**ORDER: APPROVE THE NEW SHERIFF'S DEPARTMENT PROPOSED
CHANGE ORDER #28 FOR ADDING DOWNSPOUTS AT OVERHEAD SUPPORTED
CANOPIES ALONG THE FRONT OF THE BUILDING**

RE: A New Sheriff's Department Building
and Improvements at the Detention
Center— Phase 2 (Rebid 2)
Lafayette County Board of Supervisors
PCO #28 – Add Downspouts to Aluminum Canopies

Change Proposal 028

**Downspout Elevation
@ Door 107 / Awning 'A'**

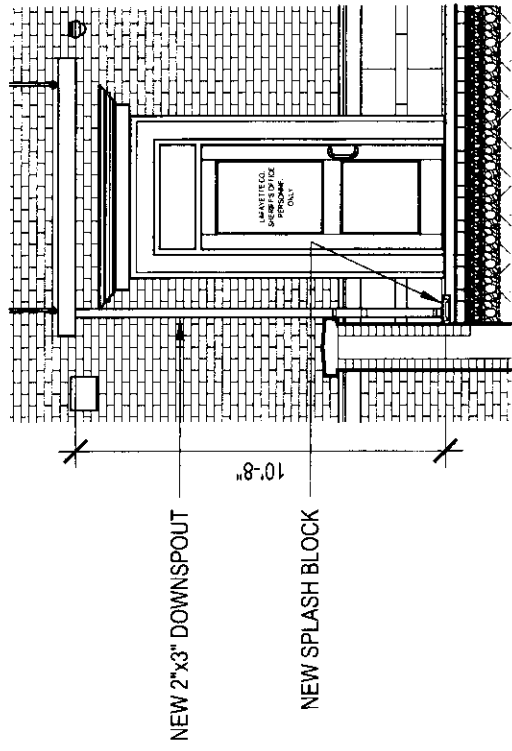
I attach the Contractor's PCO #28 to add downspouts to the two overhead-supported canopies on the front of the building, as requested by the Sheriff. The purpose of this change is to address the Sheriff's concerns with splashing and washout in the paver joints below the scupper drains located along the front edge of the canopies. The new downspouts will be located against the building and discharge onto splash blocks as shown on the attached drawing. This will also require that the slope of the canopies be reversed to drain to the rear.

Scope of Work: Change slope of 2 front canopies back to the wall and add downspouts
(2 downspouts on large canopy and 1 downspout on small canopy)
Downspouts Powder Coated to Match
